CITY PLANNING DEPARTMENT
1231 "I" STREET, SUITE 200, SACRAMENTO, CA 95814

APPLICATION: **Planning Director's Special Permit** to construct a 1,400 square foot deep lot development on 0.23± partially developed acres in the Standard Single Family Executive Airport Overlay 4 (R-1{EA-4}) zone.

LOCATION: 2432 51st Avenue
 (City Council District #5)

APPL.NO: P92-155

FRONT ELEVATION

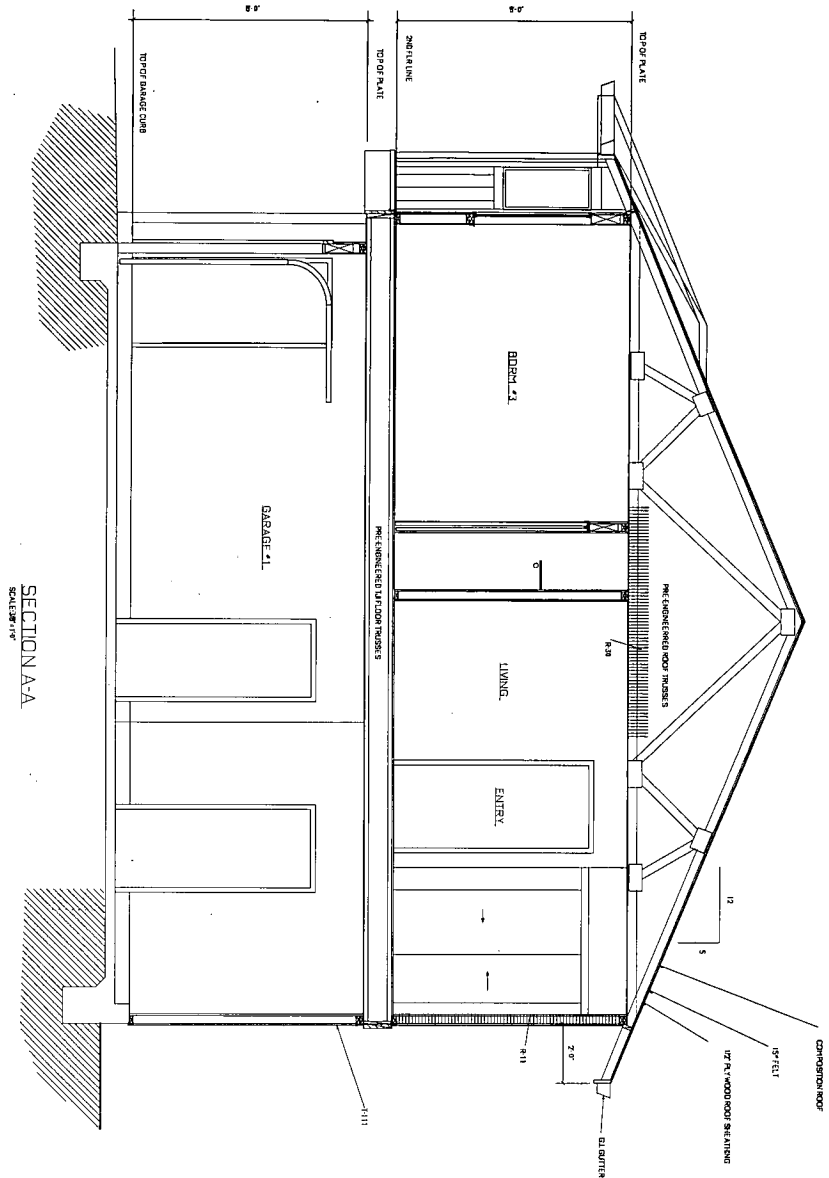
1. Landscaping (i.e. trees or other tall vegetation) should be installed along the rear property line so as to ultimately shield the view of the building from the alley and neighbors located to the south.
2. The exterior of the building should consist of stucco rather than plywood siding so as to match the texture of the existing house.
3. The bays should be modified to incorporate front facing gable type of architecture so as to match the gables of the existing house.
4. The pitch of the roof should be increased, if possible, to match the pitch of the existing house.
5. Grid-type window frames should be installed so as to match the window frames of the existing house.
6. Standard window sill and trim treatment should be incorporated into the building design (see Design Review staff for specifics).
7. A second window facing west should be installed for bedroom #2.

- c. Tall landscaping (i.e. trees or other tall vegetation) along the rear property line.
 - d. Stucco exterior.
 - e. Front facing gables.
 - f. Increased roof pitch to match the pitch of the existing house.

- g. Grid-type window frames.
 - h. Standard window sill and trim treatment subject to Design Review staff approval.
 - i. A second window facing west for bedroom #2.

SITE PLAN

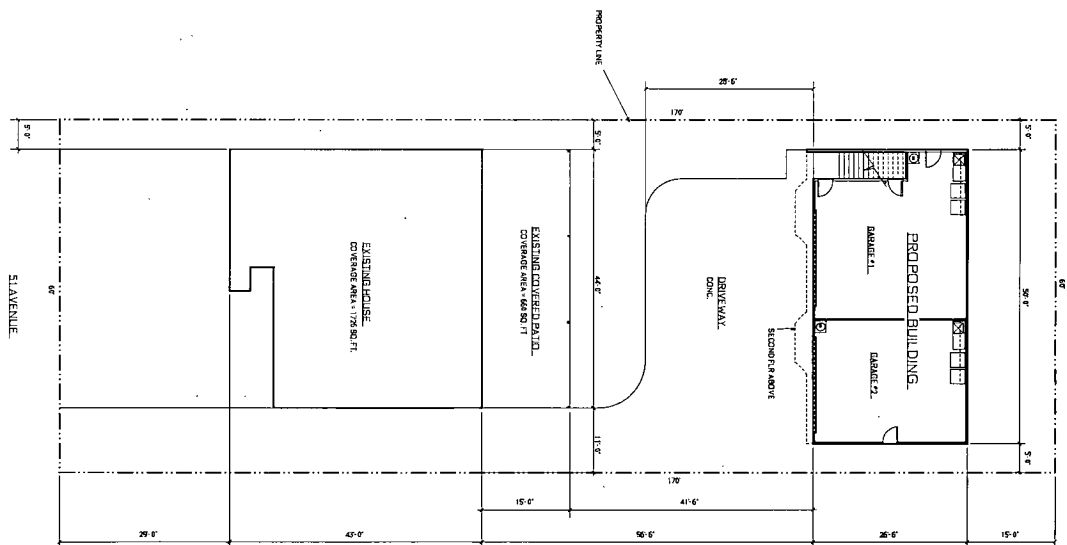
The public alley to the rear is not paved and therefore could not serve as an alternate access point for vehicles. Staff recommends that vehicular access to the proposed structure via the 20-foot public alley be prohibited.

1. Existing water and sewer services are located in the alley and may require relocation prior to construction of the proposed unit.
2. Only one water service will be allowed on this parcel.

2. Vehicle access to the second structure from the alley shall be prohibited.
3. Prior to issuance of a building permit, the following shall be required or shown on the site plans:

- a. Existing water and sewer services. These services may be required to be moved at the applicant's expense.
 - b. Only one water service shall be allowed on the subject site.
